MEMORANDUM

SUBJECT: BZA #19954 – 1519 4th Street, NW – Special exceptions to permit an addition to an existing mosque

Roof Plan, excerpted from Exhibit 6, Sheet 9, showing with a red dashed line the location of the stair tower and mechanical screen that do not meet the 1-to-1 setback.

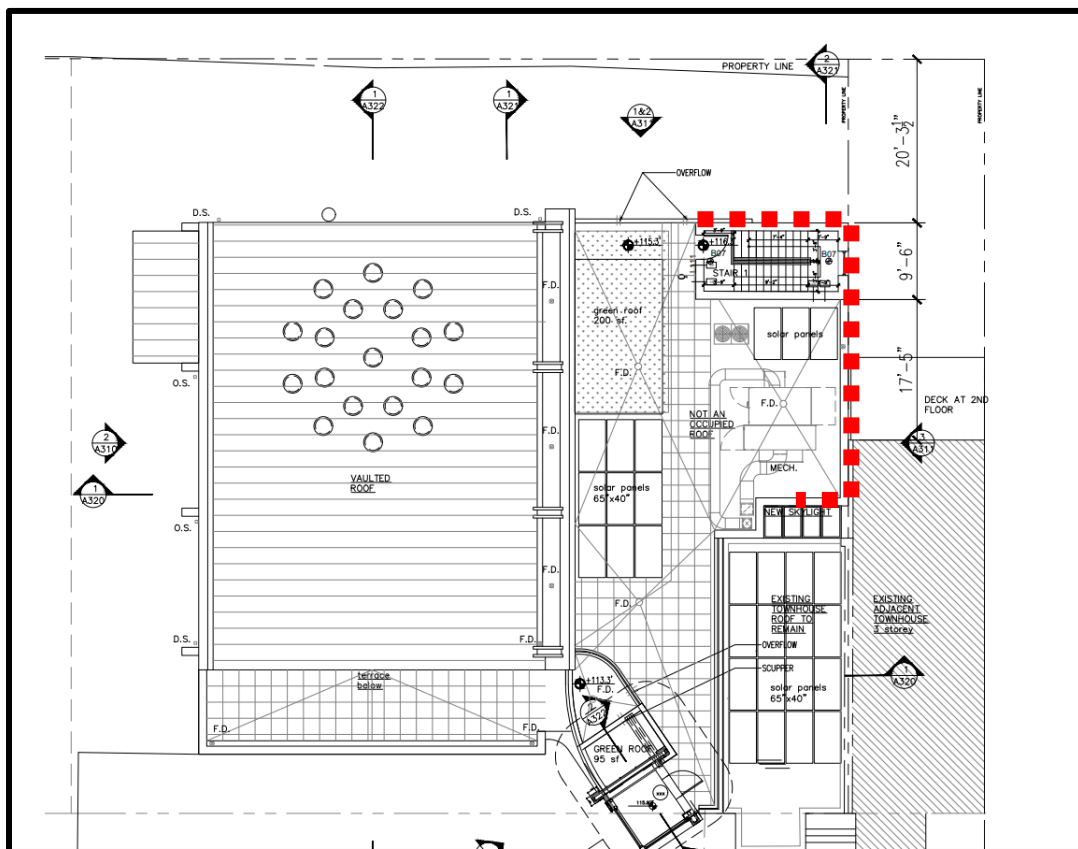
Subtitle C, § 1504.1 allows relief from the penthouse setback requirements. The applicant requests relief to permit a zero-foot setback for the rooftop stair tower and mechanical screen, as seen in the image below. OP's analysis of the criteria of § 1504 follows.

Because of the layout of the first floor, with a large, open worship space, the possible locations for a stair tower are extremely limited. Please refer to Sheet 4 of Exhibit 6. Unlike an office building, for example, where the core functions are located in the middle of the building, in a place of worship, the “core” tends to be pushed to the exterior of the building’s footprint. Because of the location of the stair tower on the roof, the most logical and efficient location of the mechanical equipment would be in the open area created along the southern wall of the building, between the stairs and the existing rowhouse.

The overall design of the building should be improved by minimizing the visibility of the roof structures from 4th Street. The penthouses would be more visible from the nearby properties on the south and east, but the applicant has indicated to OP that the brick used on the exterior walls, including the stair tower, would be varied with horizontal banding and patterns to add visual interest to those surfaces.

Locating the roof structures at the southern and eastern edges of the building should minimize the penthouses visibility from 4th Street.

Full compliance would be unreasonable given the layout of the lower floors of the building. Because of the large prayer hall on the first floor, the possible locations for a stair tower are extremely limited. Please refer to Sheet 4 of Exhibit 6. Transferring the locations of the stairs on upper stories would result in an unreasonable loss of efficiency on those floors. Because of the

location of the stair tower on the roof, the most logical and efficient location of the mechanical equipment would be in the open area created along the southern wall of the building, between the stairs and the existing rowhouse.

The applicant has stated that they made every effort to locate the penthouses in conformance with the required setbacks. Please refer to Exhibit 5, page 4. OP was also informed by the applicant that the mechanical equipment must be located where it is proposed because of programmatic constraints in the building below that govern where mechanical shafts and ducts can be located. The applicant also stated that moving the equipment to the north would impede maintenance access to the green roof and solar panels.

One intent of this chapter is to minimize the appearance of rooftop structures from public rights of way. The proposed design would push the stair tower and mechanical equipment away from the 4th Street side of the building, minimizing their visibility from the west, with very little to no impact on the light or air available to adjacent properties. When compared to a conforming solution, the position of the stair tower at the eastern edge of the building may result in a fractionally greater amount of afternoon shadow on properties to the east, but not to a degree that would result in an undue impact.
